Product / Process Change Notification (PCN)

PCN #: PCN_ConBHD_20230214
Affected Series: WE-ConBHD_61232620621
PCN Date: November 14, 2022
Effective Date: February 14, 2023

DETAIL OF CHANGE:

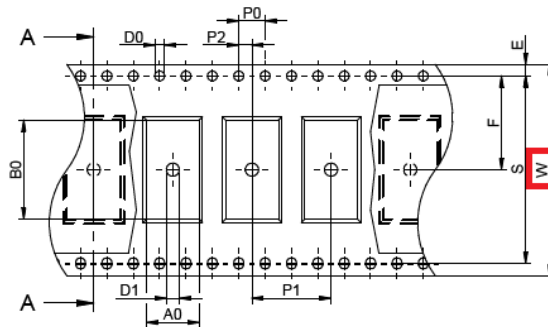
To improve the processability, Würth Elektronik will use a new tool to do the reel package PN 61232620621 and change the reel width from 72mm to 56mm. Parts per carton will change from 900 to 1200.

Reel width $W = 72\text{mm}$

Reel width $W = 56\text{mm}$

Pcs / Carton = 900	Pcs / Carton = 1200
Reliability / Qualification Summary: There will be no change of the product, therefore no additional reliability or qualification testing will be performed.
